SUBJECT: Responds to 971125 RAI re proposed amend 148a to license
DPR-43.

Docket 50-305
 Operating License DPR-43
 Kewaunee Nuclear Power Plant
Request for Additional Information Regarding Proposed Amendment 148a

Response to NRC Questions Concerning Proposed Amendment 148a

SG WIDE RANGE LEVEL vs TIME slb14myy0

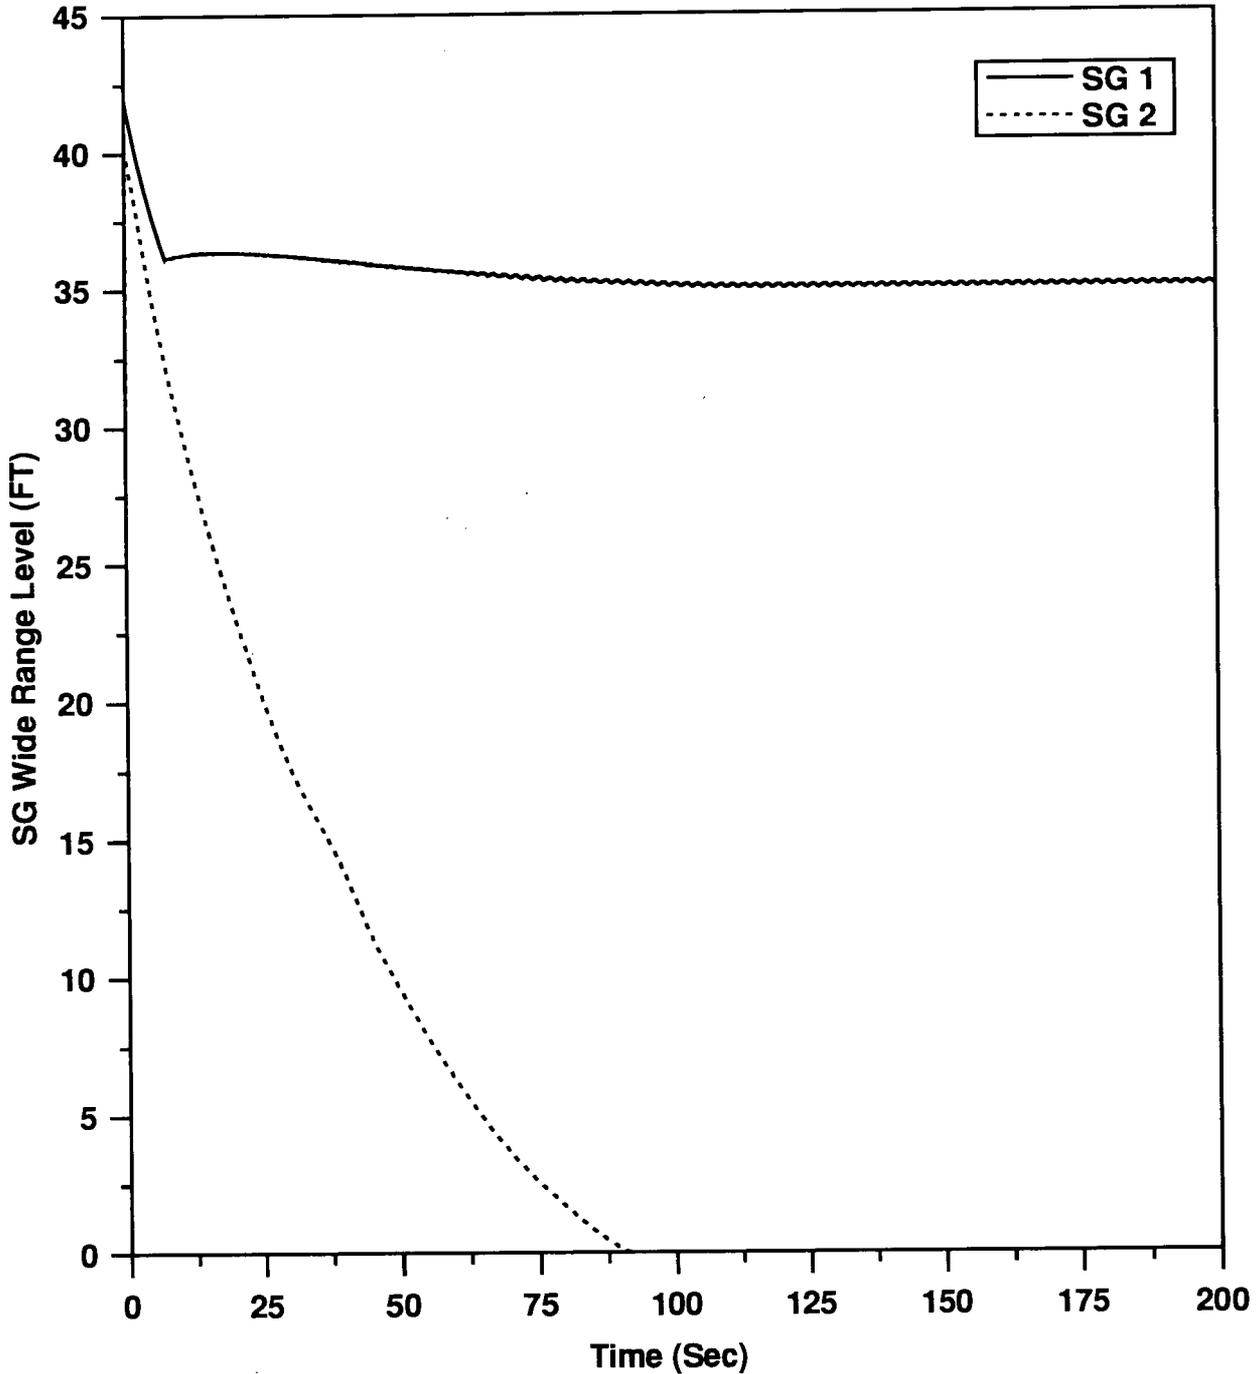
2. *In your MSLB analysis, the initial steam generator water level is assumed at 50% of the narrow-range-level span. Please provide the basis of this assumption and show that the assumption is conservative relative to the plant operational restrictions. Also, describe the SG water level assumed in the original MSLB analysis and the basis of that assumption. Confirm that the SG initial water level of 67 ft at the SG wide-range level as indicated in Figure 3 of your September 25, 1997, submittal is consistent with 50% of the narrow-range-level span.*

- b) The parameter plotted as steam generator (SG) wide range level in Figure 3 of our September 25, 1997, submittal is a non-physical SG wide range level parameter calculated by the WPSC main steam line break (MSLB) model. The trend of the model generated non-physical wide range level parameter is the same as the trend of the actual SG wide range level. An actual SG wide range level versus time plot is presented in Figure 1 of this attachment. As shown in Figure 1, the initial actual SG wide range level assumed in the analysis is 41.9 feet. This initial wide range level corresponds to 50 % level on the narrow range level indication. Figure 2 of this attachment shows the Kewaunee SG narrow and wide range level tap locations and the initial MSLB assumed water level.
